**AGENDA
REGULAR MEETING
SAN BENITO COUNTY AIRPORT LAND USE COMMISSION**

To: Airport Land Use Commission
From: Veronica Lezama, Transportation Planner Telephone: (831) 637-7665
Date: December 17, 2020
Subject: Land Use Consistency Determination

FIND Project No. 2018-23, Associated with Assessor Parcel No. 053-350-005 on the corner of Wright Road and San Felipe Road in the City of Hollister, CONSISTENT with the 2012 Hollister Municipal Airport Land Use Compatibility Plan.

FIND Project No. 2018-6, Associated with Assessor Parcel Nos. 019-090-026 and 053-350-0030 located on 1100 San Felipe Road in the City of Hollister, **CONSISTENT** with the 2012 Hollister Municipal Airport Land Use Compatibility Plan.

1 TYPICAL BASIN DETAIL
NOT TO SCALE

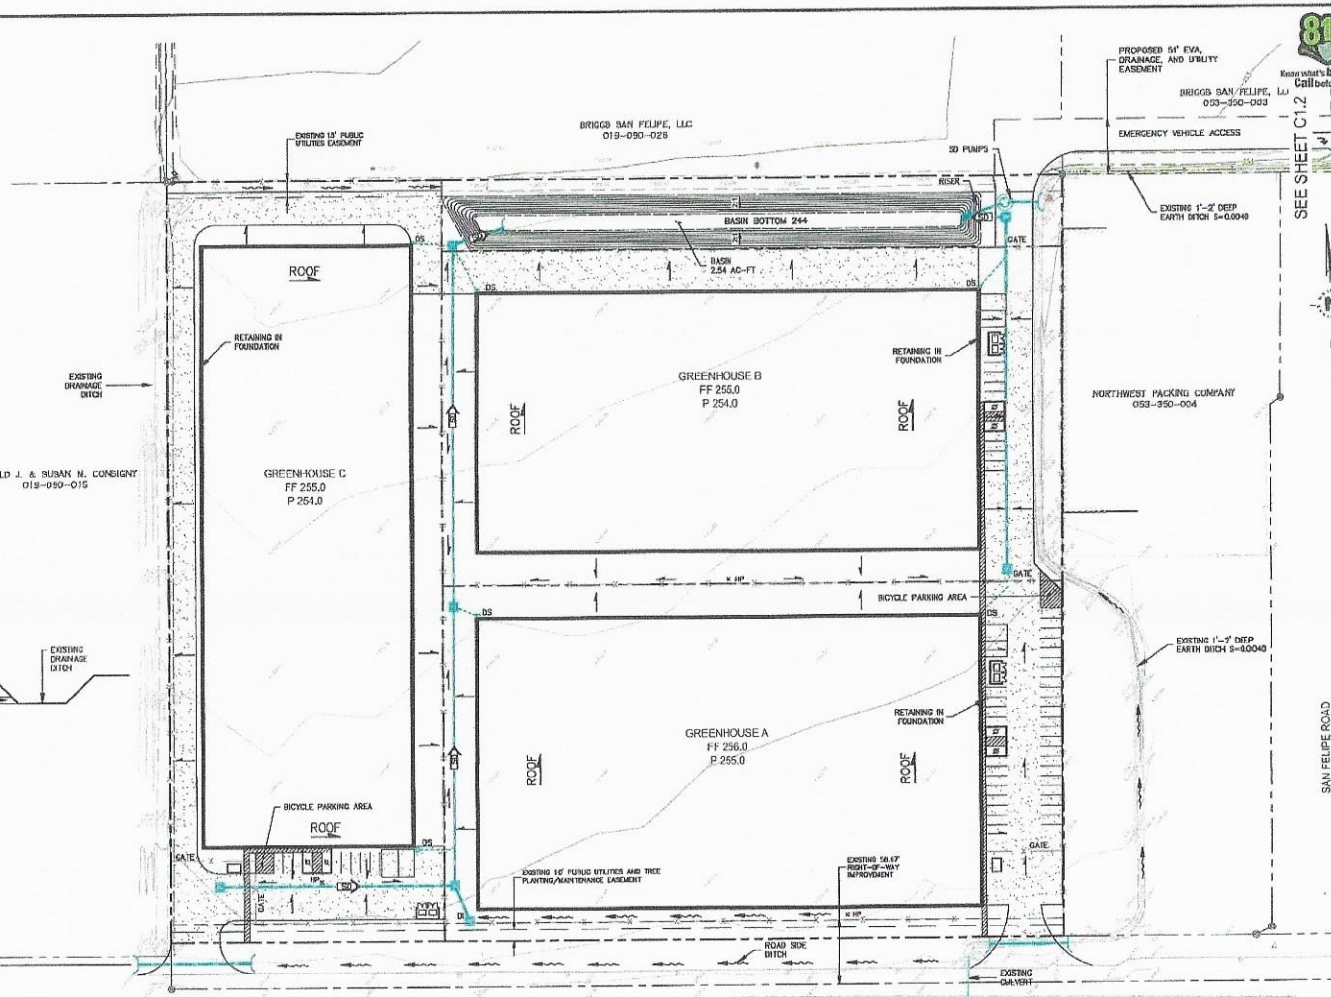
ALUC Staff Analysis: The applicant is proposing a detention basin designed not hold standing water after storm events so as to not attract birds, basin pumps shall be sized and programmed accordingly to drain within 24 hours. The detention basin design is consistent with the Compatibility Plan.

Figure 6: Time of Glare Hazard for FP2 (Clear skies year-round, Wright 13)

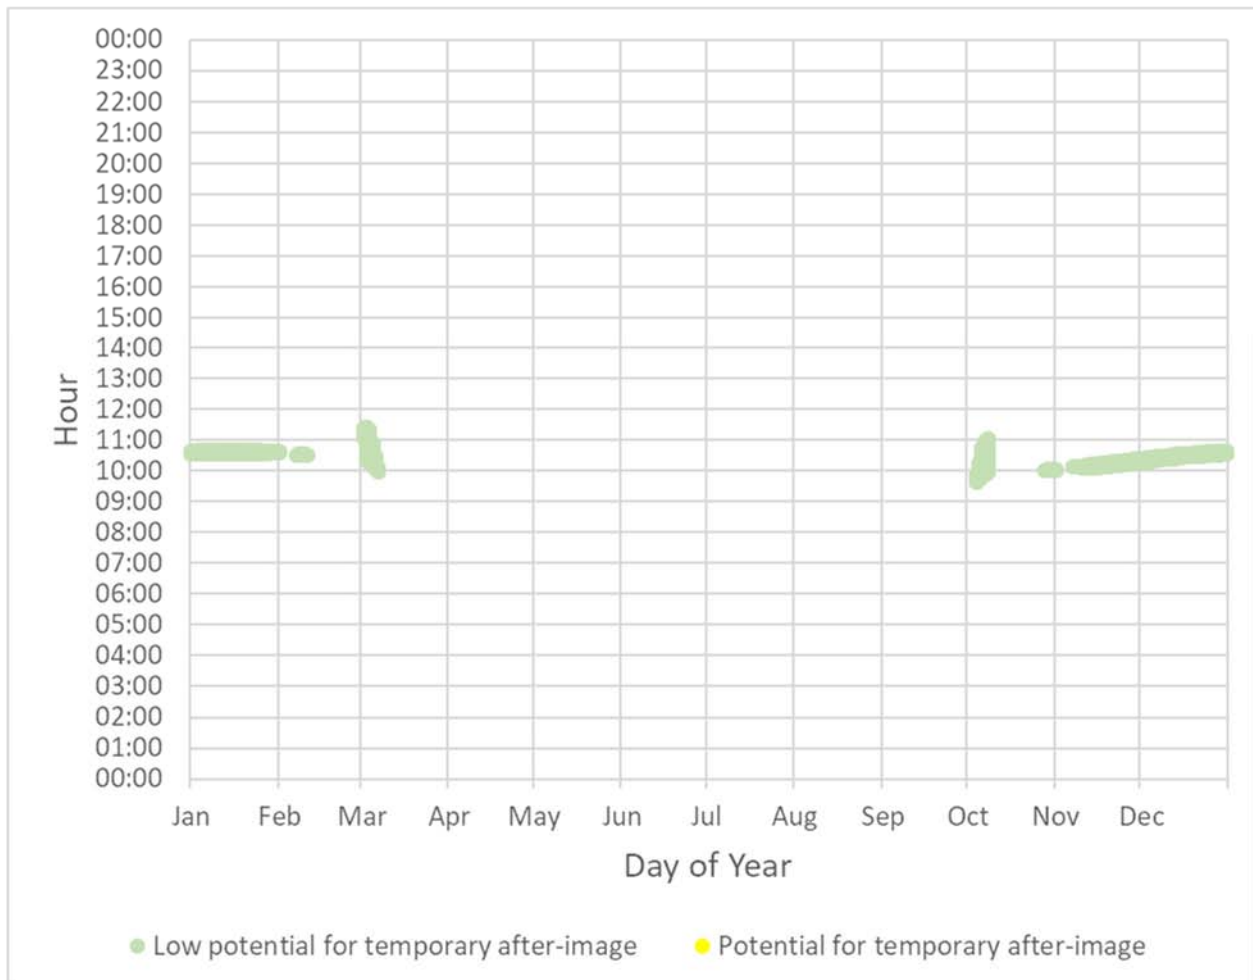
The report concluded that the preparer of the study “Solias does not expect the Wright 13 greenhouses to produce red-grade glare or yellow-grade glare at the evaluated flight paths. The model predicts green-grade glare at all flight paths evaluated. Results assume there are clear skies year-round and there is no screening between the greenhouses and the flight paths. The results of the Glare Gauge analysis identified four locations will experience green-grade glare as described in detail in the report, page 16. Green rated glare indicates a low potential for after-image.

Figure 10: Time of Glare Hazard for FP4 (Clear skies year-round, Briggs 17)

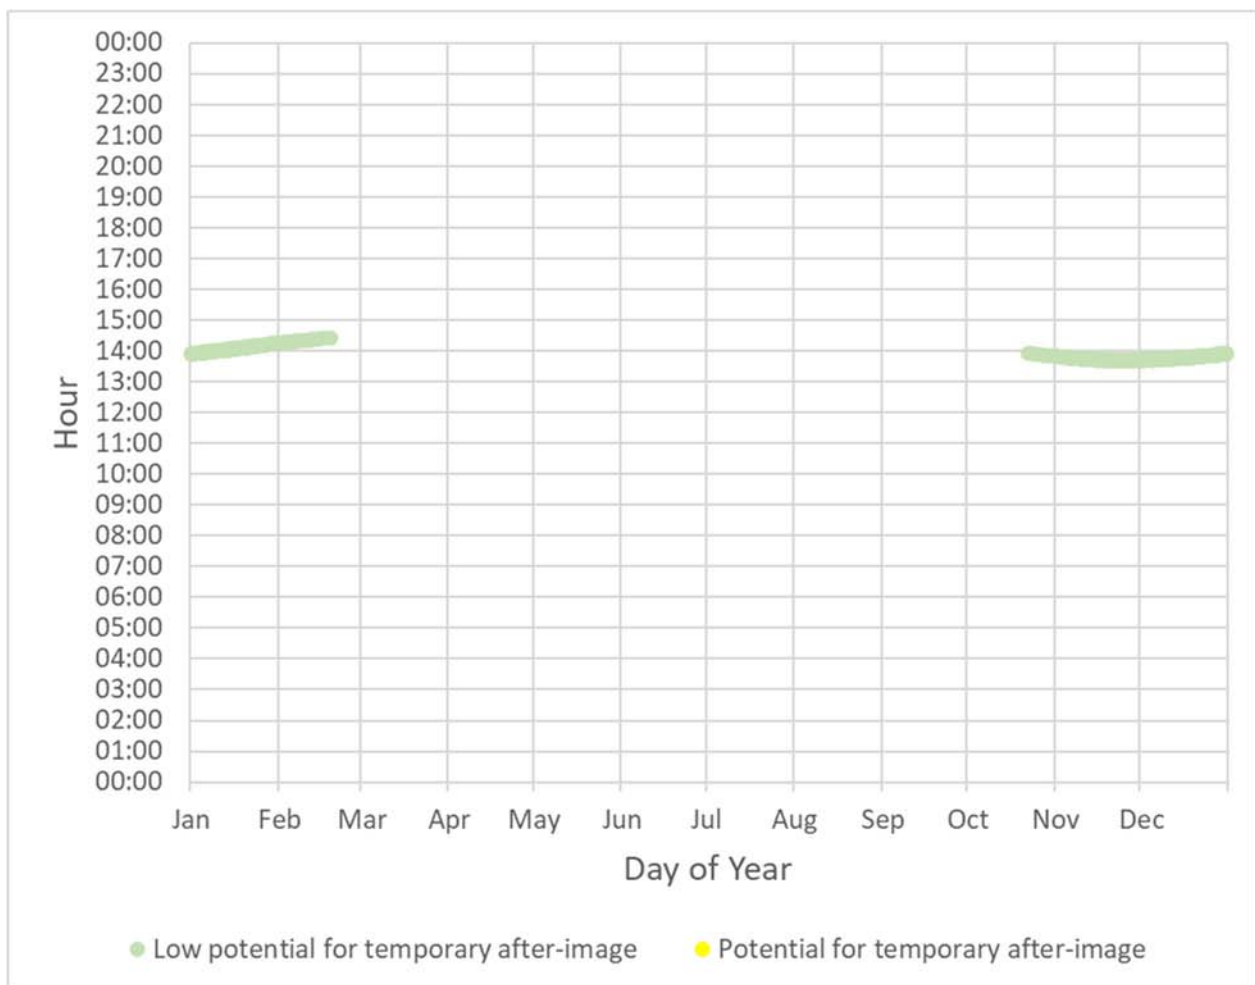
The report concluded that the preparer of the study “Solias does not expect the Briggs greenhouse to produce red-grade glare or yellow-grade glare at the evaluated flight paths.” The results of the Glare Gauge analysis identified four locations that will experience green-grade glare as described in detail in the report, page 23. Green rated glare indicates a low potential for after-image.
